December 11, 2024

MarySue Groth
Planner
Lee County Community Development, Zoning Section
1500 Monroe Street
Fort Myer, FL 33908

**Re: Town Lakes CPD Amendment
2nd INSUFFICIENCY RESPONSE LETTER
ADD2024-00149**

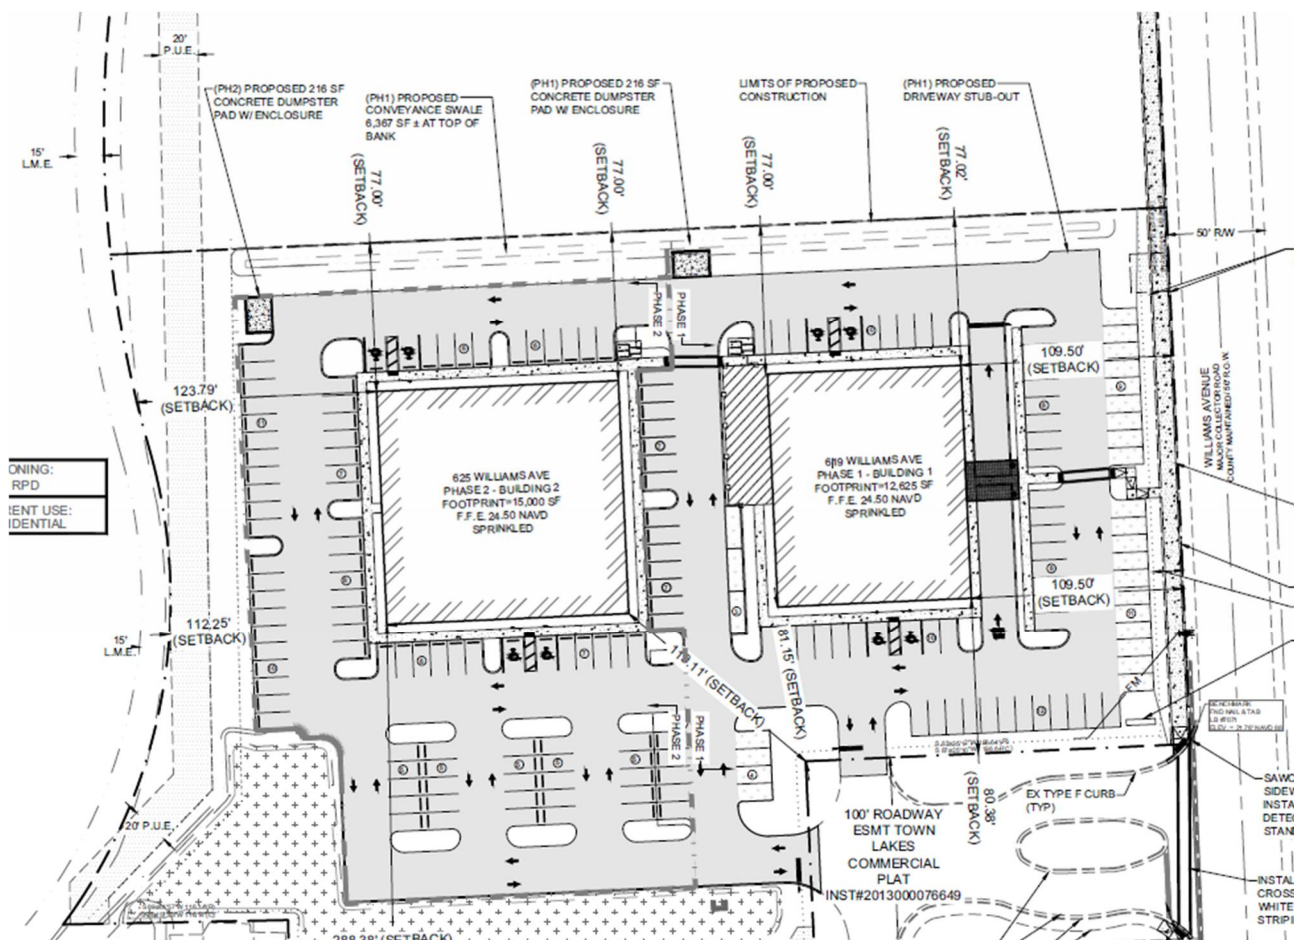
The proposed access off of Williams Ave and the proposed interconnection with the parcel to the south is not consistent with the approved Development Order plans associated with the parcel to the south (DOS2021-00079). Development Services staff acknowledges the response to comments that the interconnection is no longer desired by the parcel to the south and that the DO (DOS2021-00079) will be modified to reflect the new acreage and design. Interconnection between the sites is required pursuant to LDC Sec. [10-610(e)]. Please address or obtain the necessary deviation.

The access on Williams Ave must be shared with the property adjacent to the south (Tract A-S) to be consistent with the master concept plan MCP approved in Resolution Z-24-013.

RESPONSE: The old church approval notes a future stub out – no interconnection. The stub-out was when the anticipated expansion north would be more church development and the lot was under common ownership.

We have added Deviation #20 (from LDC 10-610(e) & 33-1412) as part of this Amendment to allow no interconnection based on incompatible uses and neither property owner nor the local public wanting the interconnection?

20. Interconnection. Deviation (20) seeks relief from the LDC § 10-610(e) and 33-1412, which state that adjacent commercial uses must provide parking lot interconnections for automobile, bicycle and pedestrian traffic, to no interconnection required between Tract A-N and Tract A-S.

JUSTIFICATION: Interconnection was never necessary but was a negotiated agreement to benefit the church as part of the land purchase from them for the

warehouse. The church has access to Williams Road via the primary entrance for the CPD. This has been in existence for a long time. The church's development order (DOS2021-00079) is in the process of being amendment with submittal going into the County and fees paid by 2024-12-06. The interconnection is removed for the DO plans for the church. The church already has legal access to Williams Road to the south as shown below. No new access to Williams will be requested or necessary. The applicant is comfortable with a condition specifying no additional access points on Williams Road will be permitted. We also acknowledge that if the use of the church property were to change that LCDOT reserves the right to reconsider the interconnection.

Interconnection between the proposes tracts in not appropriate. The uses and revised layout create incompatibilities with an interconnection that are not desired by either party. A church on Tract A-S and commercial warehouse on Tract A-N. The warehouse property has commercial traffic and is a fenced and secured property to ensure security of the storage units. There is no pedestrian pass through of the site to be used by an interconnection. Each tract is a definitively different destination.

RESPONSE: The MCP is being changed per this amendment to no longer be shared. The location of the access onto Williams is the same as previously proposed. The MCP shows 286 feet from Fountain Mist and 249 feet from the access south, same as approved in zoning.
